# CITY OF ALBUQUERQUE

RE: **Albuquerque Christian School**  
**4931 McLeod NE**  
**Grading and Drainage Plan**  
**Engineer's Stamp Date: 4/12/2018**  
**Hydrology File: F17D094**

Based upon the information provided in your submittal received 4/12/18, the Grading and Drainage Plan is approved for Building Permit.

| SHEET TITLE     | Grading Plan   | SHEET NO. | 1           |

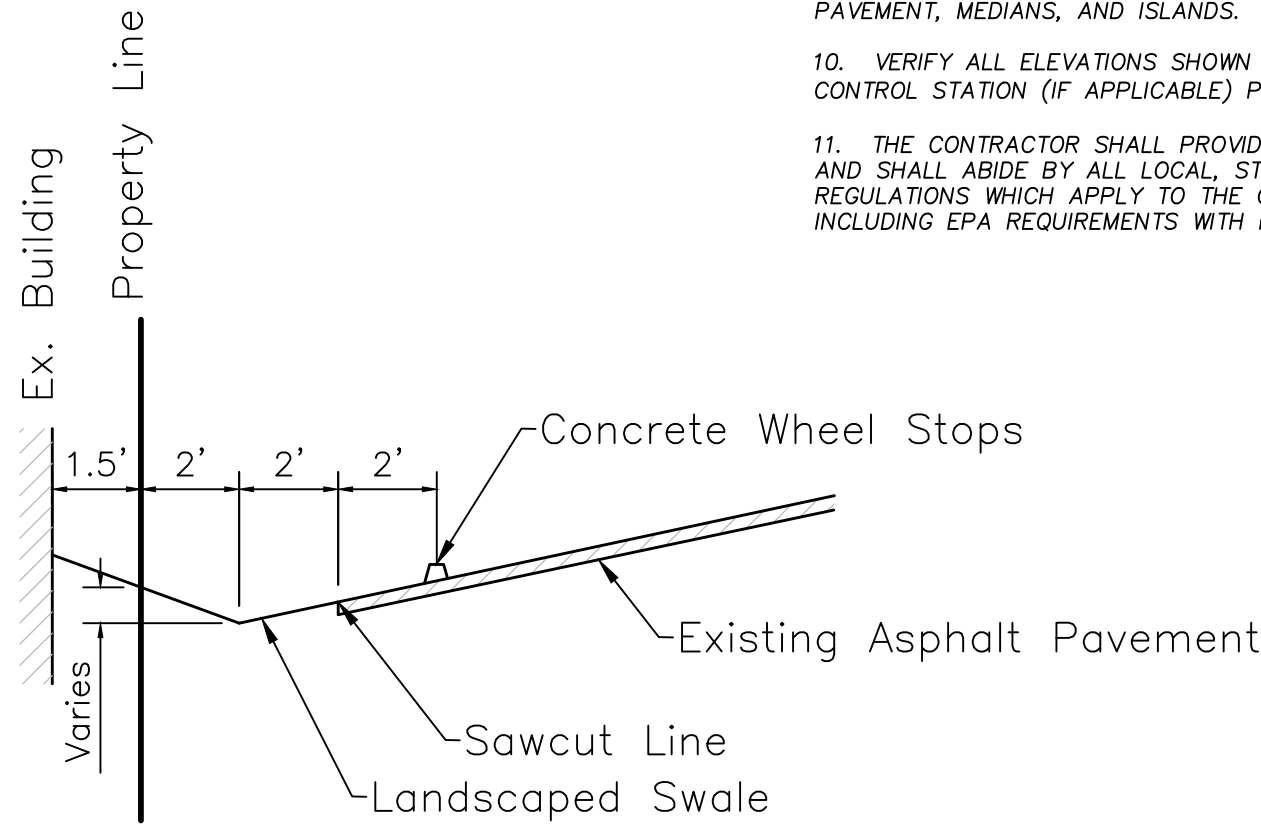
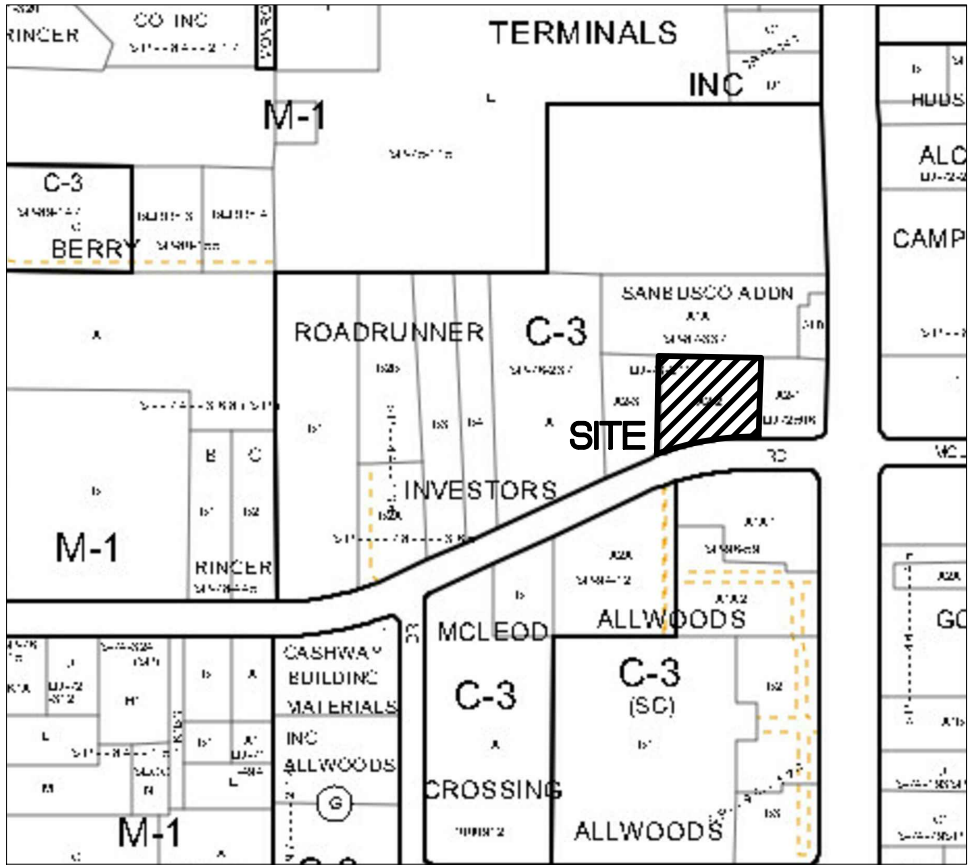
The proposed walls are shown as inset from the property line; if this changes and any encroachment across the property line is made, written and signed permission will need to be granted by the adjoining owner. If you have any questions, please contact me at 924-3695 or [dpeterson@cabq.gov](mailto:dpeterson@cabq.gov).
